Charlotte-Mecklenburg Planning, Design, & Development

SUBJECT: Administrative Approval for Petition No. 1999-055 Chris Azar

Zoning Petition
1999-055
Arbor Creek
Townhomes
2601 Archdale Drive
Charlotte NC

SUBJECT: Administrative Approval for Petition No. 1999-055 Chris Azar

2 Street Elevation
 1/4" = 1' - 0"

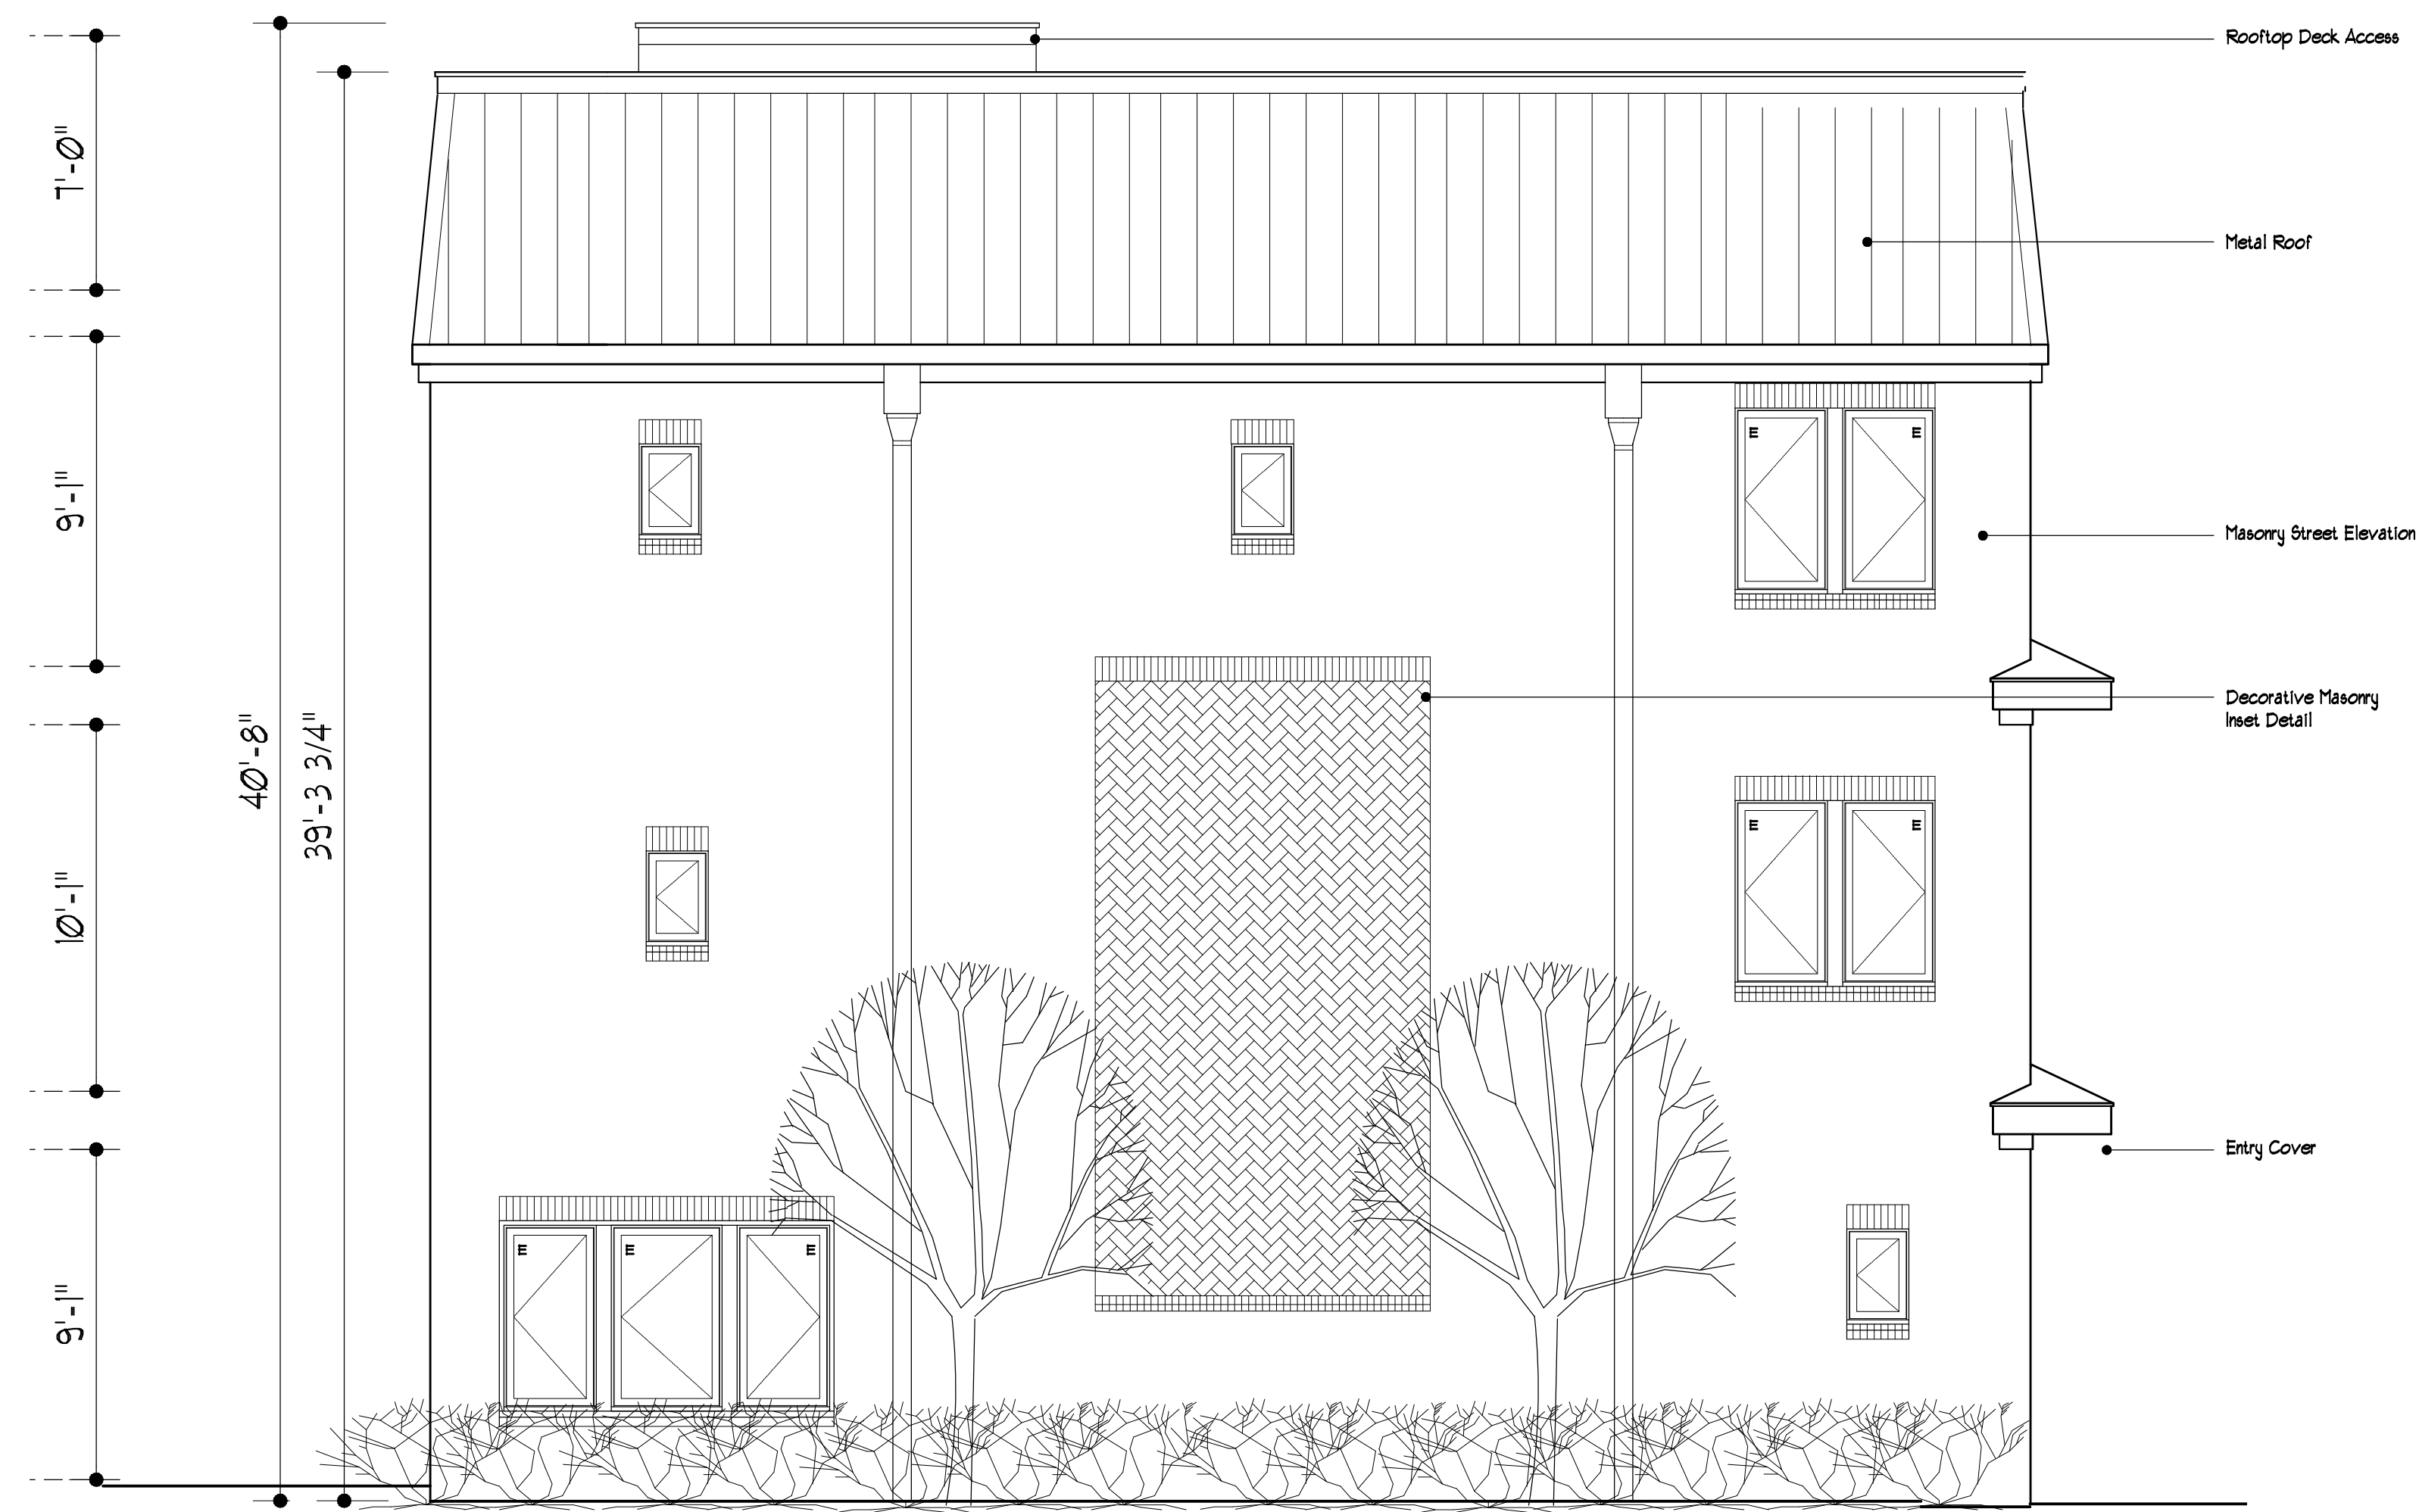
- Site modifications to allow garage units
- Revised building elevations

The Units will Alternate Brick Veneer 4 Vinyl Siding Cementitious Siding
All End Elevations will be Brick
